Report: 1547 TAB REPORT
Function: Test, Adjust, & Balance
Date: 07/24/2025
Completed By: National TAB

PROJECT
07-21-25 WHATABURGER #1547 DULUTH,
GA

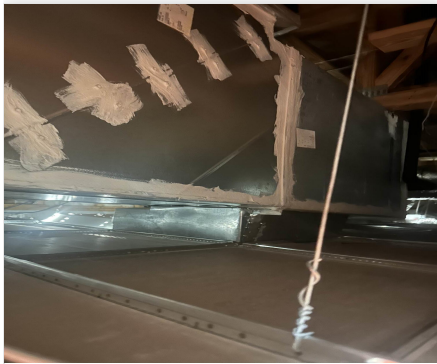
Issue Name : DUCTWORK INSULATION
Description : The initial drops and returns for both RTUs are not externally insulated. The return duct is also not internally insulated, and the technician was unable to verify if the supply was internally insulated either.
Created By : National TAB **Assigned To :** National TAB - Ben Searles
Status : Open
Priority : Medium **Asset Tag :**
Originated Date : 07/24/2025 - Ben Searles - National TAB

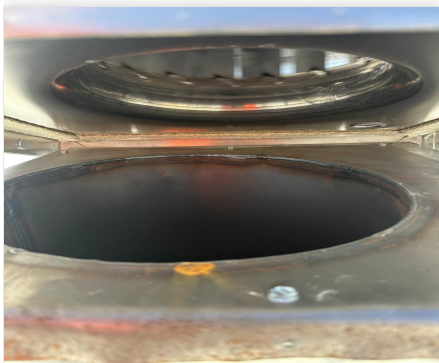
Issue Name : KEF2 GREASE DUCT
Description : The grease duct does not align with the intake of KEF2. This discrepancy did not appear to affect the balance, as the technician was able to achieve the design airflow while staying below FLA.
Created By : National TAB **Assigned To :** National TAB - Ben Searles
Status : Open
Priority : Medium **Asset Tag :**
Originated Date : 07/24/2025 - Ben Searles - National TAB
